**FLAP ASSEMBLY SCREW JACK P/N 11-45621-1  
& 11-45622-1**

Inspection of Flap Screw Jack Assembly to verify correct configuration of the assembly.

**Figure 1 Correct Configuration**

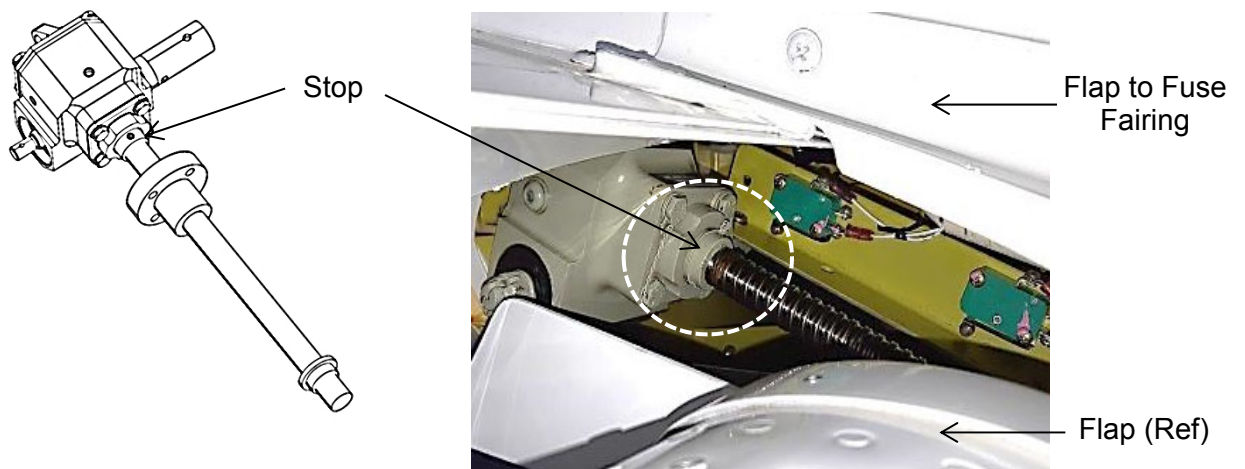
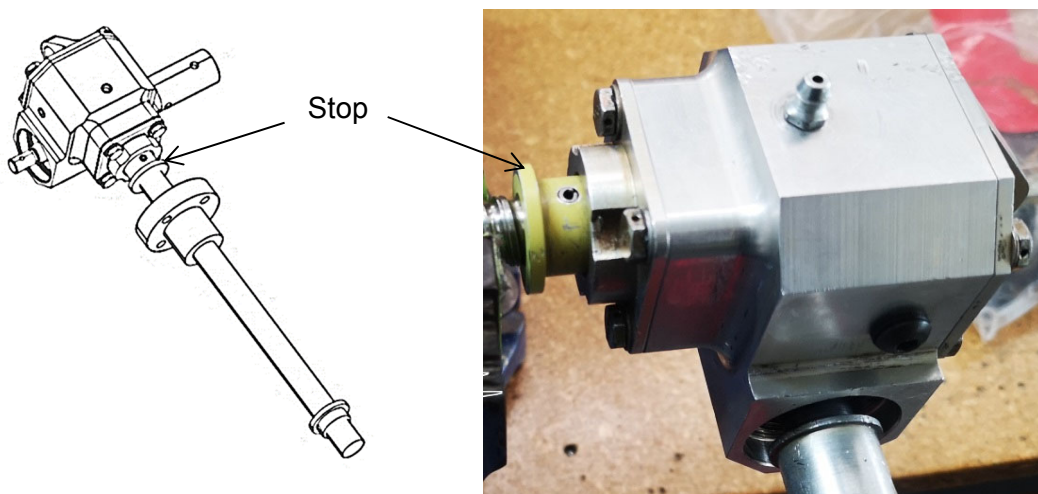
- A.1) Switch the battery power 'ON' and lower the flap to 40°.
- A.2) Carry out visual inspection of the Screw Jack Assembly on both sides to check the configuration (Ref Figure 1).
- A.3) If the Screw Jack Assembly is fitted with correct 'Stop' orientation as shown in Figure 1, no further actions are required.

- A.4) Operator to record compliance in aircraft logbook.
- A.5) If the Screw Jack Assembly is fitted with incorrect configuration of the 'Stop' as shown in Figure 2, go to Part-B.

- B.1) Remove the Screw Jack Assembly.
- B.2) Disassemble the Screw Jack. Refit the 'Stop' as shown in Figure 1.
- B.3) Reassemble the Screw Jack.
- B.4) Reinstall the Screw Jack Assembly.
